Z-56
(2017)

**WIGLEY RD. TRACT
RESIDENTIAL COMMUNITY
ZONING PLAN**

PETITION NO: Z-56

ZONING COMMENTS:

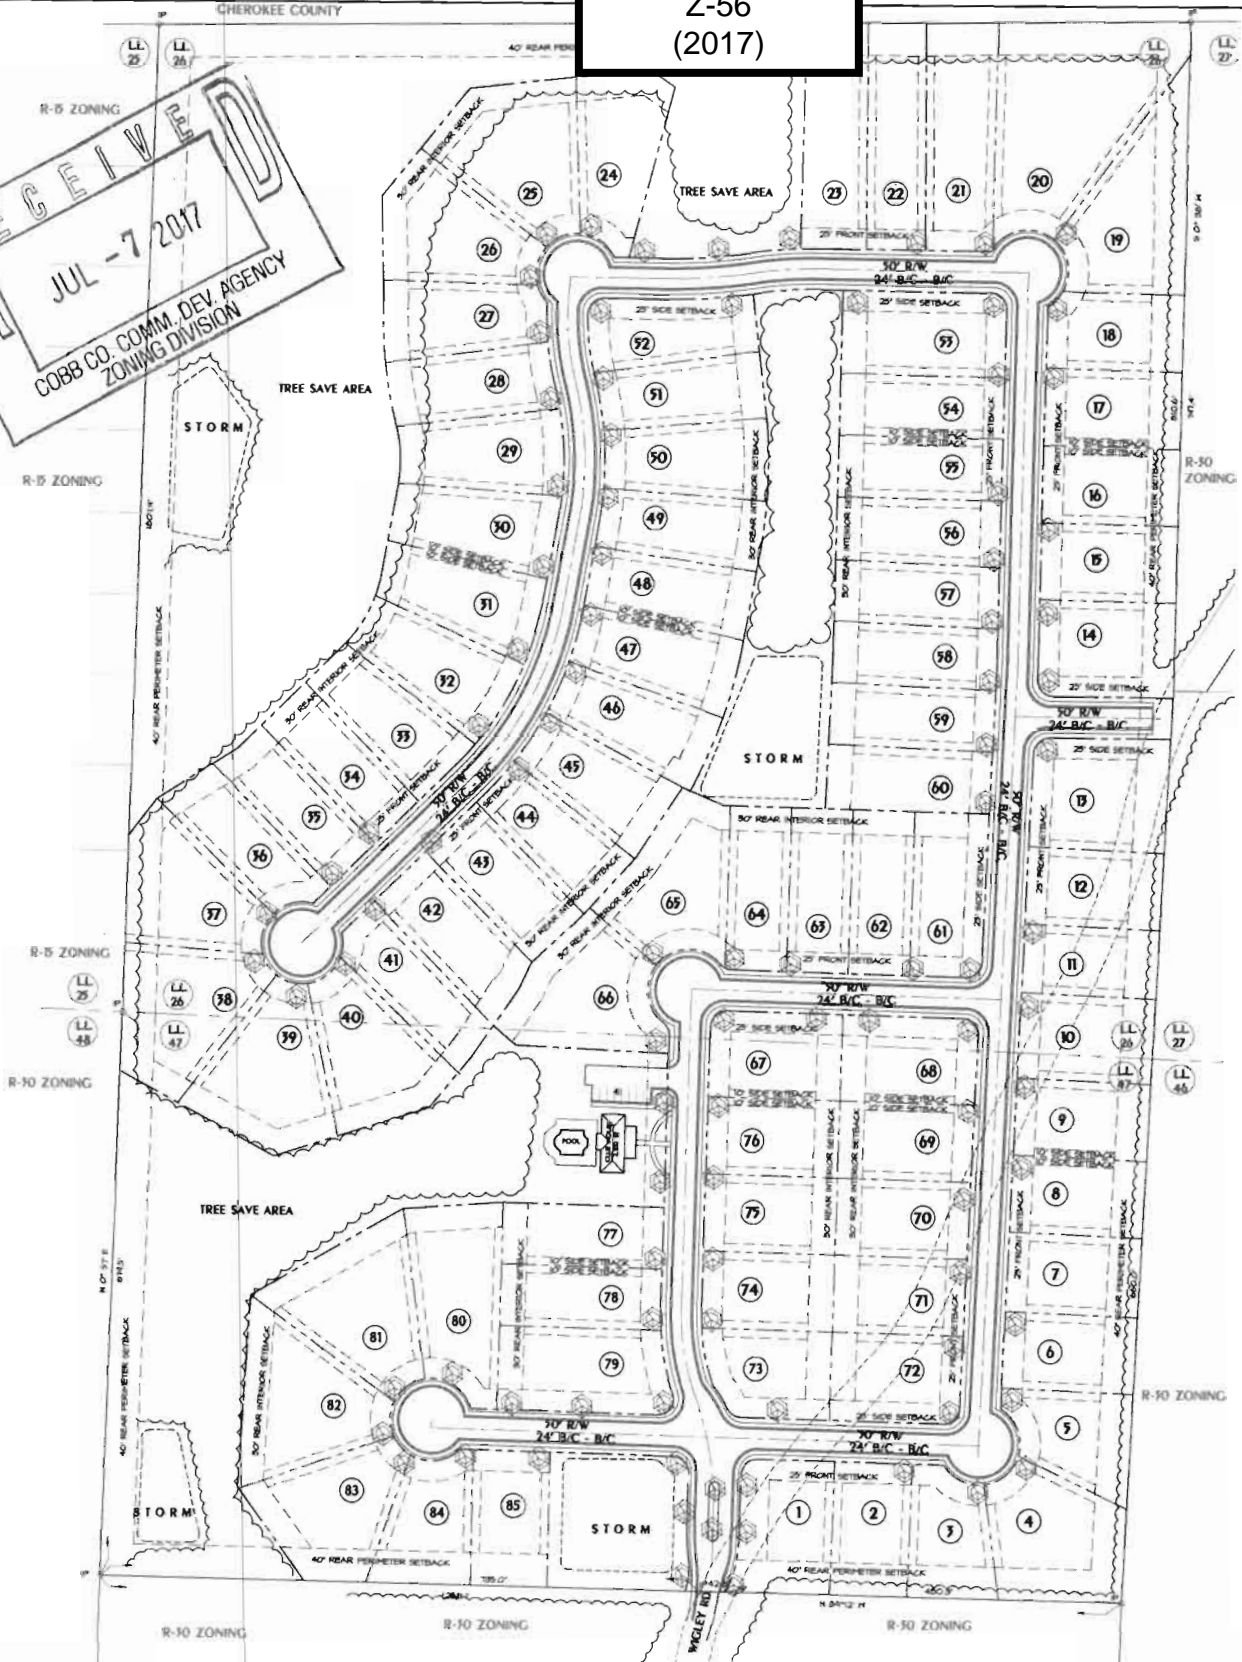
The proposed site plan will require the following contemporaneous variances:

1. Waive the front setback on all lots from the required 35 feet to 25 feet; and
2. Waive the public road frontage on cul-de-sac lots from 50 feet to 38 feet.

Additional Comments: The Falcon Crest Lift Station, which would serve lots outfalling to the west, has limited excess capacity. Easement(s) and flow study may be required based upon final sewer design.

1. This site is located on the northern portion of Wigley Road. The site lies on a steep ridgeline and drains in three directions. The majority of the site (40%) drains to the south roughly parallel to Wigley Road. Approximately 35% of the site drains to the northeast along Wigley Road into Cherokee County. The remaining 25% of the site drains to the west into and through the adjacent Falcon Crest Subdivision. The site is predominately wooded with steep slopes ranging from 12 to 40%. The site layout needs to be sensitive to the steep topography. A preliminary rough grading plan should be provided to verify feasibility of the proposed layout.

2. Stormwater management for the site will be provided by multiple onsite detention ponds. The pond locations may need to be adjusted to limit grading required and to adequately control runoff from the development.

3. As indicated in the Downstream Conditions comments above, there is an existing lake located approximately 300 feet downstream. A pre- and post-development sediment study will be required to document any sediment impacts to this lake. Elevated onsite erosion control measures will be required due to the steepness of the site.

4. A downstream headwater pool analysis will be required for the existing receiving culvert in Falcon Crest S/D to verify no adverse impact. The basement at 2254 Hawk Trace is located significantly below the low point of the road.

Wigley Drive is classified as a local and according to the available information the existing right-of-way does not meet the minimum requirements for this classification.

The existing Wigley Road right-of-way will need to be abandoned prior to Land Disturbance Permit.

Recommend a traffic study. The traffic study should include existing and base year (full build out year) Build and No Build analysis; and horizon year (base year + 10 years) Build and No Build analysis. Study assumptions (such as study intersections, trip distribution and annual growth rate) should be agreed to by Cobb DOT before completing the study.

- A. It is Staff's opinion that the applicant's rezoning proposal may not permit a use that is suitable in view of the use and development of adjacent and nearby properties. Almost all of the properties on this part of Wigley Road are zoned R-30 (only a portion of this part of Wigley Road is not zoned R-30).

- B. It is Staff's opinion that the applicant's rezoning proposal may have an adverse effect on the usability of adjacent or nearby property. The property is severely impacted by steep slopes and staff is concerned about erosion issues downstream and downslope. Other developments, zonings and densities in the area include: Jefferson Township Phase Five (zoned PD at approximately 0.32 units per acre); The Summit at Sweat Mountain (zoned R-30 at 0.72 units per acre); Bluffs at Jamerson (zoned R-20 at approximately 1.60 units per acre overall for Phases 1 and 2); Hampton Ridge Unit IV (zoned R-15 at 1.65 units per acre); and Falcon Crest Subdivision Unit III (zoned R-15 at approximately 2.50 units per acre).

- E. It is Staff's opinion that there are existing and changing conditions affecting the use and development of the property which give supporting grounds for denying the applicant's rezoning proposal. The surrounding area of Wigley Road is zoned as R-30. The steep slopes on the property, if developed in a more intense manner, can impact surrounding and downstream properties. Larger lot R-30 development would be preferable due to less grading activity. Staff is aware that other neighborhoods in this area have caused drainage and sedimentation problems due to smaller lot sizes on steep slopes.

Based on the above analysis, Staff recommends **DENIAL**.
